Mr. Jensen Uchida
San Joaquin Cross Valley Loop Transmission Project
Environmental Science Associates
225 Bush Street
Suite 1700
San Francisco Ca. 94104-4207

Good evening, my name is Joe Ferrara, the purpose of this statement is to provide comment regarding the DEIR that has been prepared on the Southern California Edison San Joaquin Cross Valley Loop KV Transmission Line Project. My wife Mary and I are landowners adjacent to the Proposed Route 1. I am a member of a farming family that has farmed in the Exeter to Lemon Cove corridor for ninety years. I believe that my general knowledge of this area and the hydrological issues that are specific to this area give me the necessary background to make the following observations and statements. I appreciate the opportunity to speak to you this evening.

DISTRIBUTION SYSTEM
EXETER IRRIGATION DISTRICT

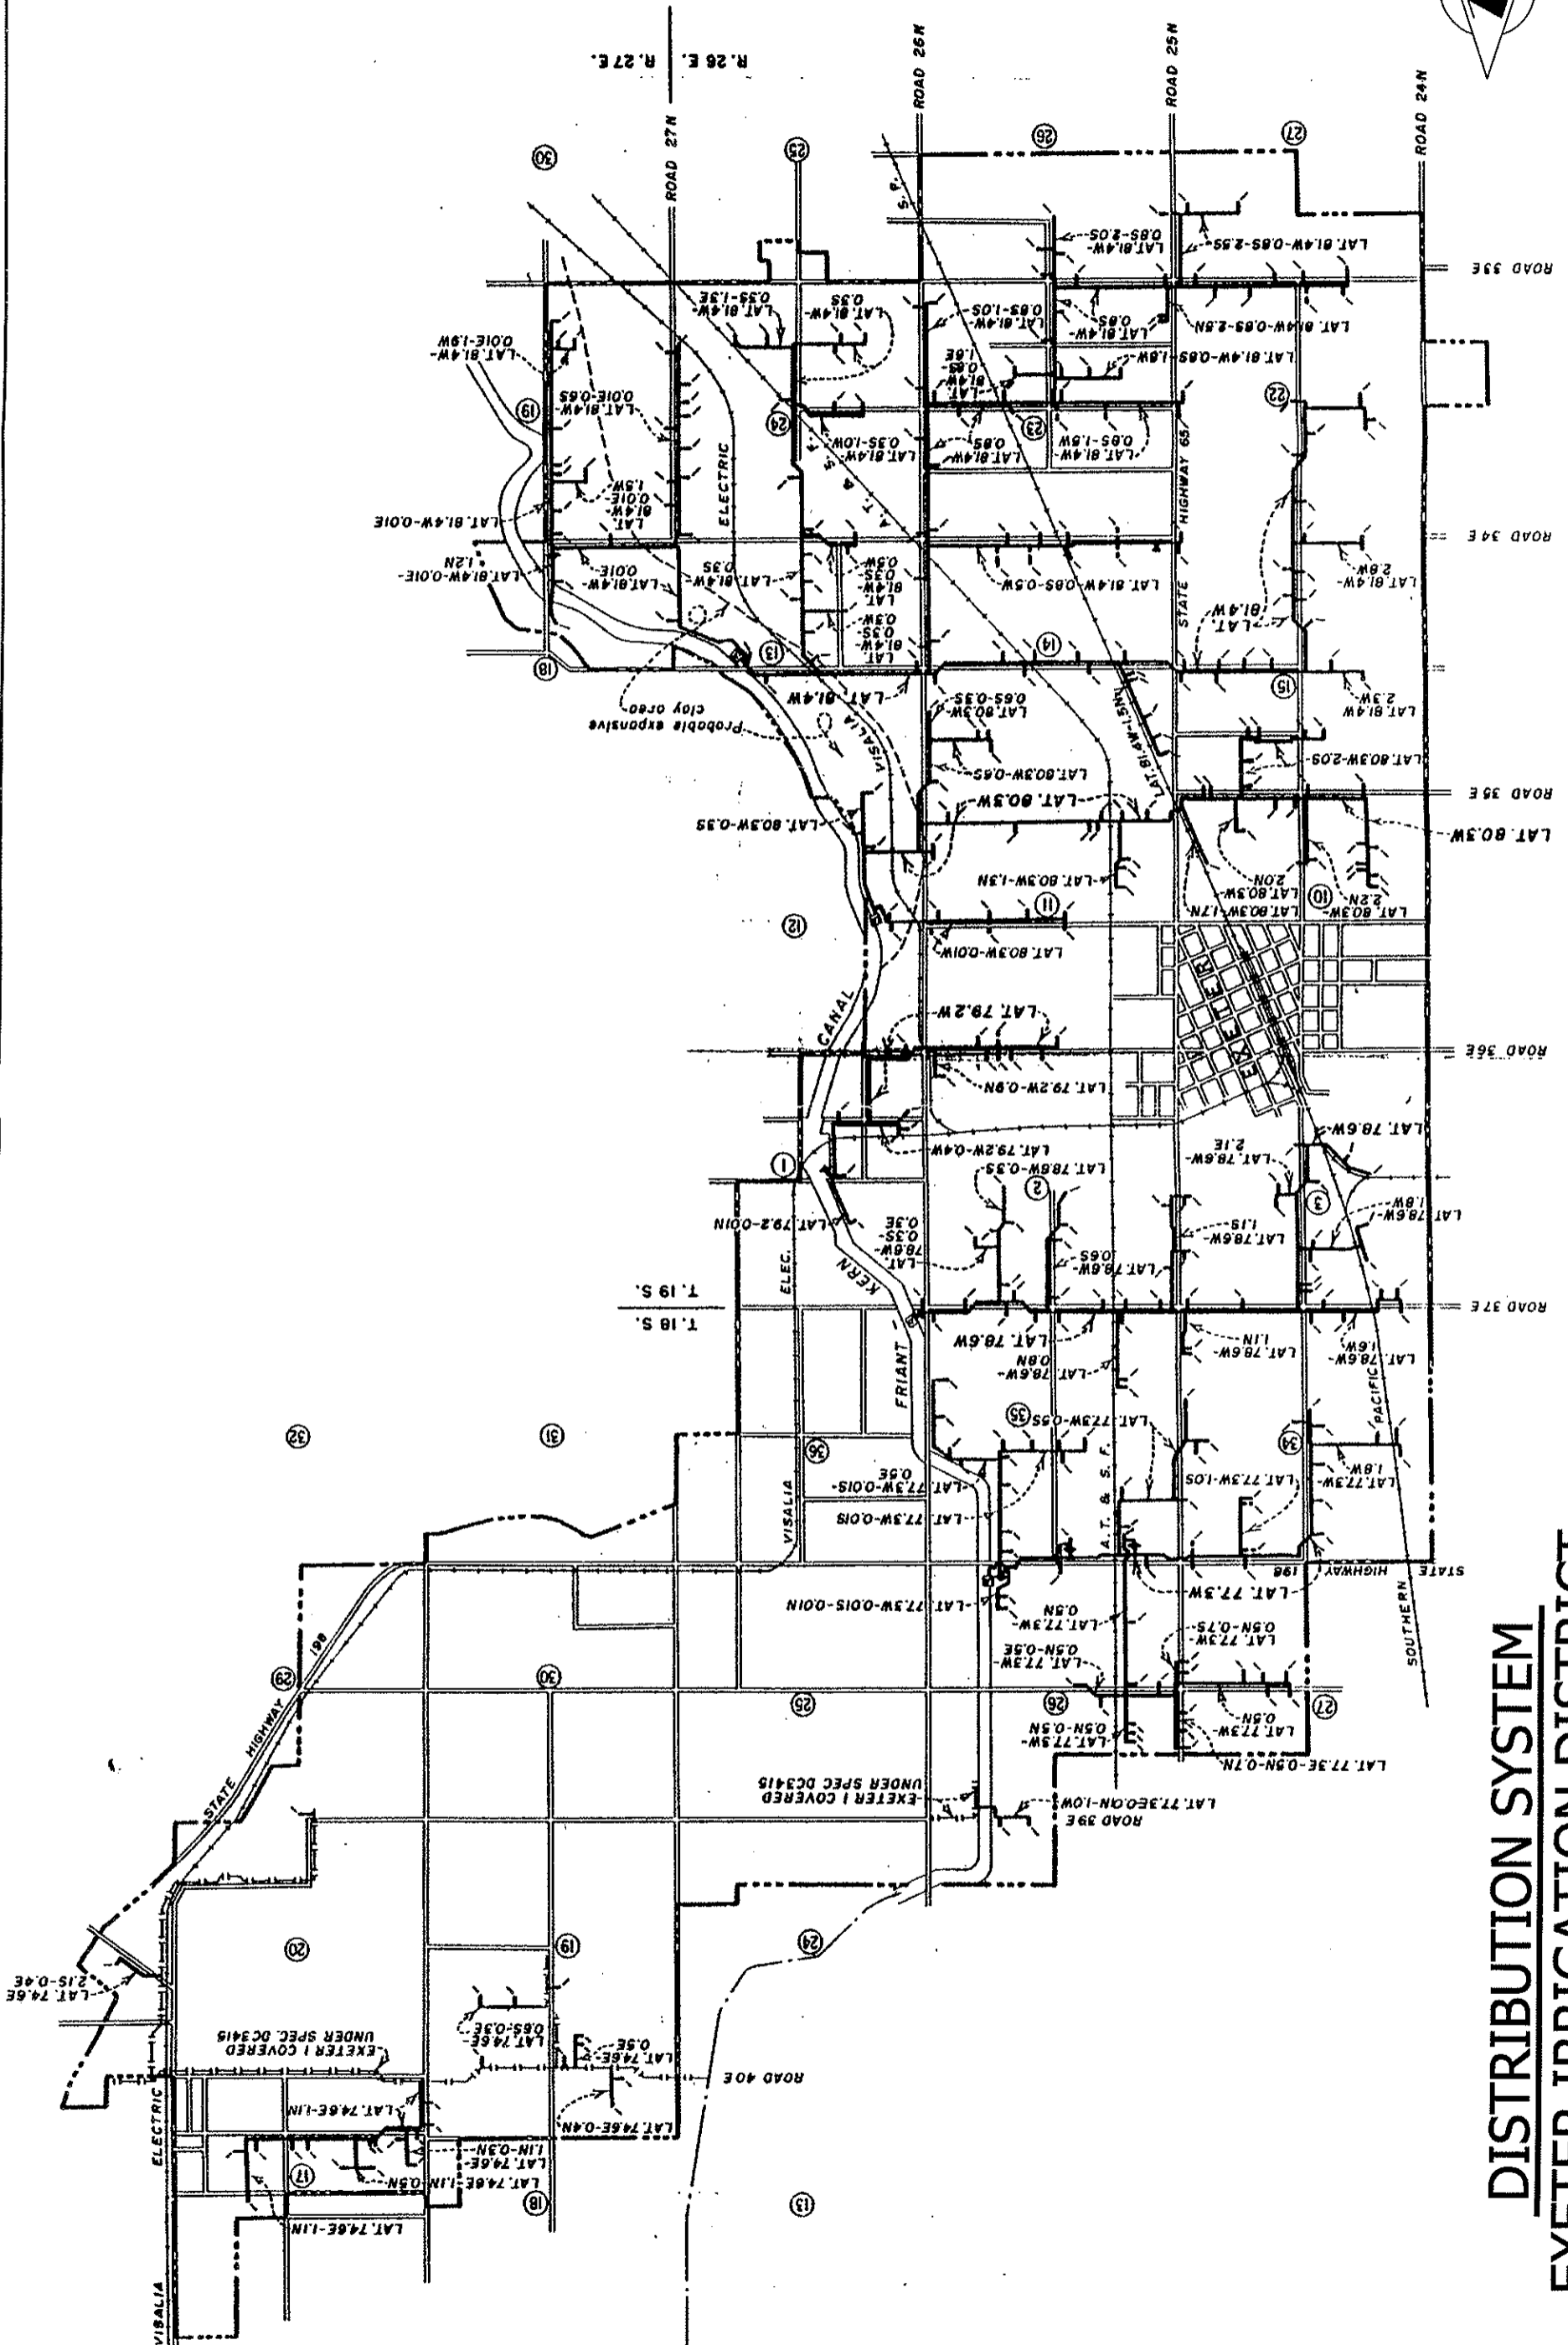
I think it is important to note that there has been no mention of the Exeter Irrigation District's distribution system. The District encompasses approximately 12,700 irrigated acres, and also includes the majority of the city limits of Exeter. Exeter Irrigation District is comprised of approximately 15,200 acres in total. The entire system includes approximately sixty miles of underground pipeline ranging from twelve inches to forty-two inches in diameter. The depth of the District pipelines range between five feet to fourteen feet. The district has approximately four hundred sixty-eight meters, serving three hundred ninety customers. In addition, the District has many turnouts, air vents, pumping stations, and reservoirs as part of the infrastructure. Total replacement cost for the district infrastructure is estimated to be at least one hundred million dollars. The proposed SCE Route 1 runs adjacent to, crosses several times and is in close proximity of District pipelines and above ground infrastructure. A thorough survey of the impacts that the proposed route would have to the entire Exeter Irrigation District's distribution system needs to be conducted. In discussions with Exeter Irrigation District management I have been

informed that no inquiries by either Southern California Edison Co. or Environmental Science Associates have been made concerning any potential environmental impacts that proposed Route #1 would have to the Exeter Irrigation District. This system was professionally engineered, and designed by the Bureau of Reclamation. The infrastructure of the Exeter Irrigation District has served the agricultural community of this area for almost sixty years. Major design changes to the underground pipelines or above ground infrastructure that would impact the ability to deliver water efficiently would have to be mitigated.
